# UNITED STATES PATENT AND TRADEMARK OFFICE

APPLICATION NO.	FILING DATE	FIRST NAMED INVENTOR	ATTORNEY DOCKET NO.	CONFIRMATION NO.
10/707,113	11/21/2003	Tzu-Ching Tsai	11003-US-PA	1112
31561	7590	06/17/2004	EXAMINER	
JIANQ CHYUN INTELLECTUAL PROPERTY OFFICE			THOMAS, ERIC W	
7 FLOOR-1, NO. 100			ART UNIT	PAPER NUMBER
ROOSEVELT ROAD, SECTION 2			2831	
TAIPEI, 100				
TAIWAN

<b>Office Action Summary</b>	<b>Applicant No.</b>	<b>Applicant(s)</b>	
	10/707,113	TSAI ET AL.	
	<b>Examiner</b>	<b>Art Unit</b>	
	Eric W Thomas	2831

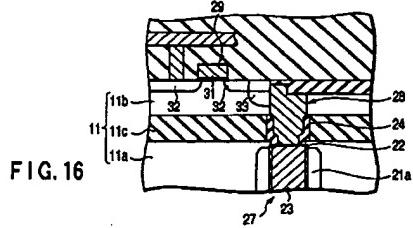
2. Claim 12 is objected to because of the following informalities:

Claim 12, line 9-11, the limitation, "a collar oxide layer, formed on sidewalls of the top of the deep trench, the substrate at sidewalls of the top of the deep trench exposed" is confusing.
